35-TYPE CONVERTER SETS — ADJUSTMENTS

APPARATUS AFFECTED: 35A, 35B, 35D, 35E, 35F, 35G and 35H Converter Sets.

- (1) To simplify adjustment methods and requirements.
- (2) To revise and update wiring diagrams.

8.19 GEAR MECHANISM

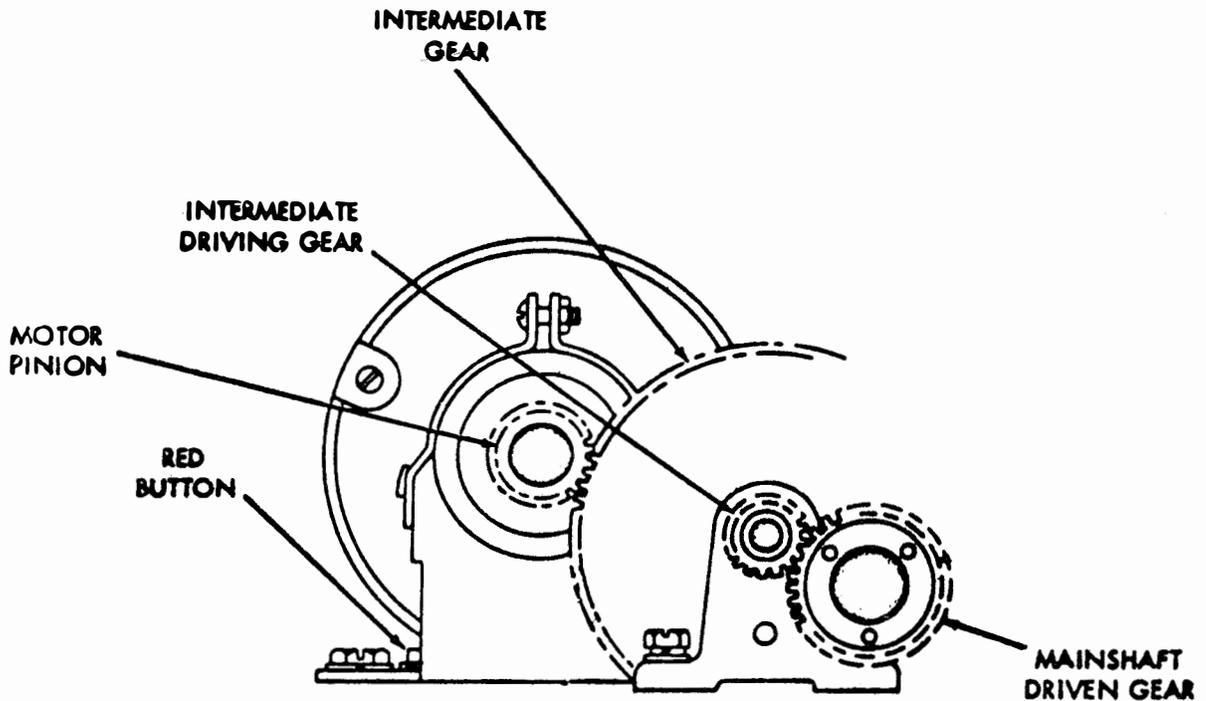
(A) Tape Reader Gear Backlash

The location of subparagraph (A) on page 30 has been changed and will read as subparagraph (B) Tape Reader Gear Backlash.

The requirement (A) Tape Reader Gear Backlash has been changed:

From: "Only a perceptible amount of backlash between main shaft driven gear and intermediate driving gear."

To: "Only a perceptible amount of backlash between main shaft driven gear and intermediate driving gear at point where backlash is least."

(B) Intermediate Shaft

The location of subparagraph (B) on page 30 has been changed and will read as subparagraph (A) Intermediate Shaft.

The requirement of Min. 0.015 inch—Max. 0.020 inch has been deleted.

"To Adjust" of new (A) Intermediate Shaft, has been changed:

From: To Adjust.

Position the intermediate shaft assembly to the forward plate loosened.

To: To Adjust.

Loosen the two intermediate gear bracket screws and position intermediate gear bracket.

The note to subparagraph (B) Intermediate Shaft, has been changed:

From: Note: Intermediate shaft adjustment required only on miniaturized base.

To: Note: In some cases, it may be necessary to loosen the motor mounting screws and position the motor to meet the requirements.

REQUIREMENT

ONLY A PERCEPTIBLE AMOUNT OF BACKLASH BETWEEN THE MOTOR PINION AND INTERMEDIATE GEAR AT POINT WHERE BACKLASH IS LEAST.

TO ADJUST

LOOSEN THE TWO INTERMEDIATE GEAR BRACKET SCREWS AND POSITION INTERMEDIATE GEAR BRACKET.

NOTE: IN SOME CASES IT MAY BE NECESSARY TO LOOSEN THE MOTOR MOUNTING SCREWS AND POSITION THE MOTOR TO MEET THE REQUIREMENT.

(B) TAPE READER GEAR BACKLASH

REQUIREMENT

ONLY A PERCEPTIBLE AMOUNT OF BACKLASH BETWEEN MAINSHAFT DRIVEN GEAR AND INTERMEDIATE DRIVING GEAR AT POINT WHERE BACKLASH IS LEAST.

TO ADJUST

LOOSEN THREE TAPE READER MOUNTING SCREWS AND POSITION TAPE READER.
